HORSHAM DISTRICT COUNCIL CONSULTATION

TO:	Horsham District Council – Planning Dept
LOCATION:	Land To The West of Shoreham Road Small Dole West Sussex
DESCRIPTION:	Outline planning application for up to 45 dwellings (including affordable homes) with all matters reserved apart from access.
REFERENCE:	DC/25/1019
RECOMMENDATION:	More Information / Modification

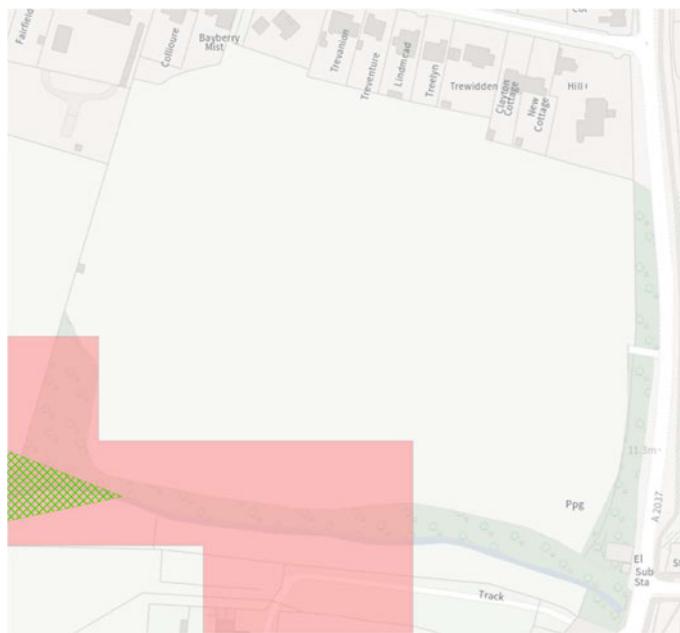
All habitats within the metric have been inputted as having a low strategic significance (area/compensation not in local strategy/no local strategy). However, please note that the south of the site comprising the priority woodland and watercourse fall within a very high potential site of the Wilder Horsham District Nature Recovery Network, and therefore as per HDC guidance, all habitats with a biodiversity value greater than zero within the metric should be assigned as having a medium strategic significance (location ecologically desirable but not in local strategy). It is therefore requested that the strategic significance for habitats in this area is amended.

^Red and green shading above indicate areas that fall within the WHD NRN route.
